Access Compliance Report

Public Rights-of-Way

(Curb Ramps)

Intersection ID: 12560	Main Street: WILKINSON_BV	Cross Street: WEYLAND_AV	Location: NE
ADA ID: D0B488F5C23A	Ramp Type: Perp	Initial Pass/Fail: Fail	Overall Compliance: No
Severity Score: 21.25			
Codes/Mitigation Info/Possible Solution		Field Measurements/Component Compliance

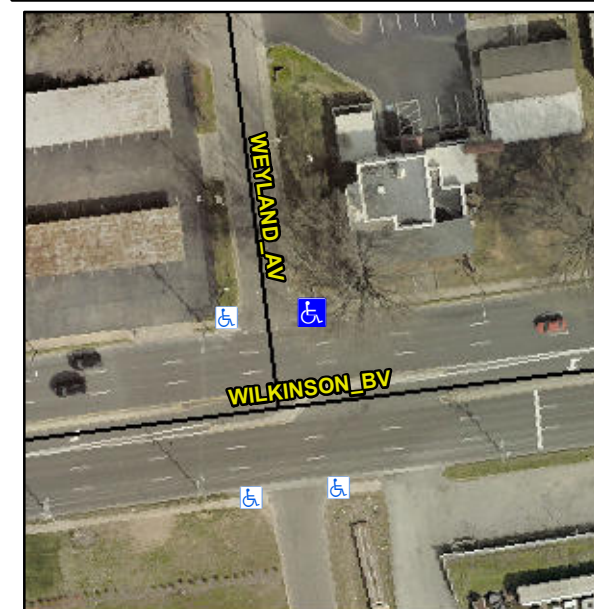
Not Found, R304.5.1, R304.2.2

Compliance	Description	Data	Compliance	Description	Data
N/A	Ramp Length (in)	37.5	No	Ramp Slope (%)	10.1
No	Ramp Width (in)	36.0	Yes	Ramp XSlope (%)	1.9
N/A	Flare Type LT	N/A	N/A	Flare Type RT	N/A
N/A	Flare Slope LT (%)	N/A	N/A	Flare Slope RT (%)	N/A
N/A	Flare Traversable LT?	N/A	N/A	Flare Traversable RT?	N/A
N/A	Landing Length (in)	N/A	N/A	DWS Provided?	N/A
N/A	Landing Width (in)	N/A	N/A	DWS Contrast?	N/A
N/A	Landing Slope (%)	N/A	N/A	DWS Length (in)	N/A
N/A	Landing X Slope (%)	N/A	N/A	DWS Full Width?	N/A
N/A	Landing Curb? (Y/N)	N/A	N/A	DWS Offset (in)	N/A
N/A	Shared Landing?	N/A			
N/A	Gutter Ponding?	N/A	N/A	Gutter Slope (%)	N/A
N/A	Gutter Lip Ht (in)	N/A	N/A	Gutter X Slope (%)	N/A
N/A	Painted X Walk1?	No	N/A	Painted X Walk2?	N/A
	X Walk 1 Direction	To W		X Walk 2 Direction	N/A
N/A	X Walk 1 Width (in)	N/A	N/A	X Walk 2 Width (in)	N/A
	X Walk 1 Slope (%)	0.1		X Walk 2 Slope (%)	N/A
	X Walk 1 X Slope (%)	2.0		X Walk 2 X Slope (%)	N/A

Remove & Replace Entire Ramp.
